Mask Set Errata for Mask 1L31R

This mask set errata applies to the mask 1L31R for these products:

- MC9S08GB60
- MC9S08GT60
- MC9S08GB32
- MC9S08GT32
- MC9S08GT16

Figure 1. HCS08 SIM Reset Lockup

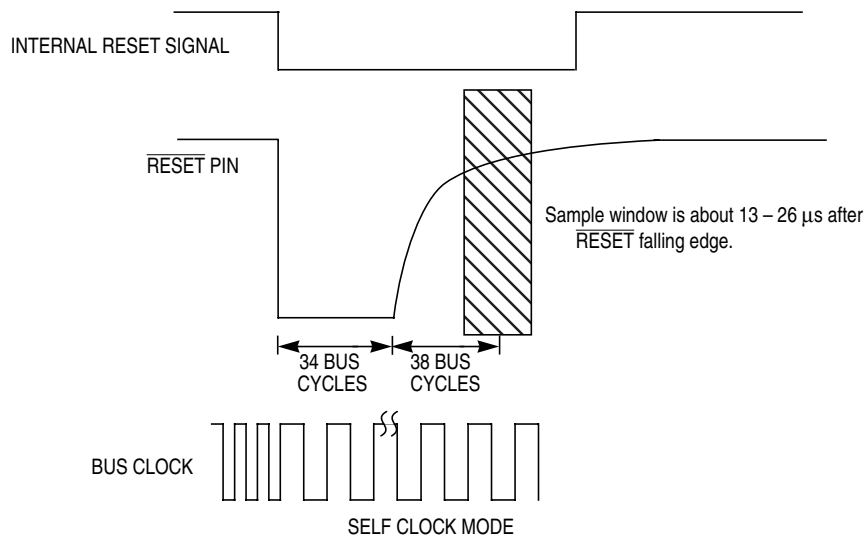
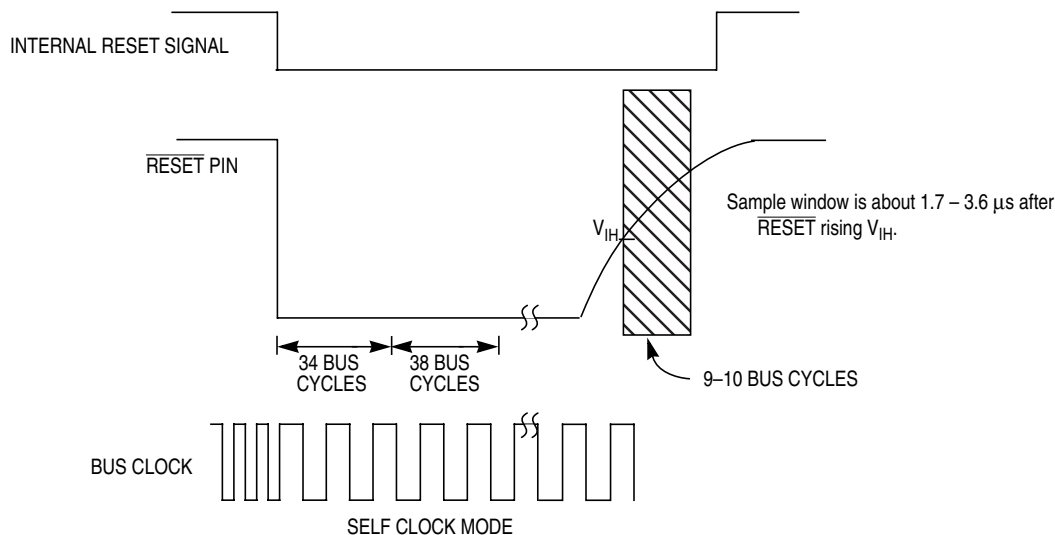
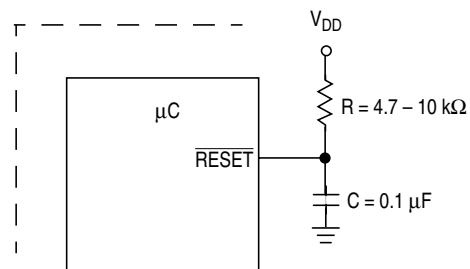
If a falling edge is detected on the external reset pin at either of two sample points, the MCU will cease operation and will recover only after a power-on reset.

Case 1 — After detecting a reset signal, either internal or external, the internal reset circuit latches the cause of the reset, forces a low level on the external $\overline{\text{RESET}}$ pin for about 34 bus cycles, releases the pin, and samples the pin level about 38 bus cycles later. The ICG will revert to self-clock mode (SCM) at the beginning of the reset cycle. Therefore, the first sample window is about 13 μs to 26 μs after the initial reset signal, due to the frequency range and characteristics of the internal oscillator.

Case 2 — After remaining in reset for an extended period of time due to an externally applied low level on $\overline{\text{RESET}}$, the internal reset circuit will sample the pin level about 9 to 10 bus cycles after the pin raises above its V_{IH} level. The ICG will revert to self-clock mode (SCM) during reset. Therefore, the second sample window is about 1.7 μs to 3.6 μs after the reset signal rises above V_{IH} , due to the frequency range and characteristics of the internal oscillator.

To avoid multiple edges on the $\overline{\text{RESET}}$ pin due to switch contact ringing or EMC noise, eliminate any voltage bounce through RC filtering. A 0.1 μF capacitor to ground and an external 4.7 k Ω to 10 k Ω resistor to V_{DD} works well to ensure noise suppression.

In addition to RC filtering, avoid spurious edges on the $\overline{\text{RESET}}$ pin caused by external active circuitry such as low voltage detectors and watchdog components. Do this by ensuring that external circuitry cannot drive $\overline{\text{RESET}}$ low within 10 bus cycles of the release of $\overline{\text{RESET}}$.
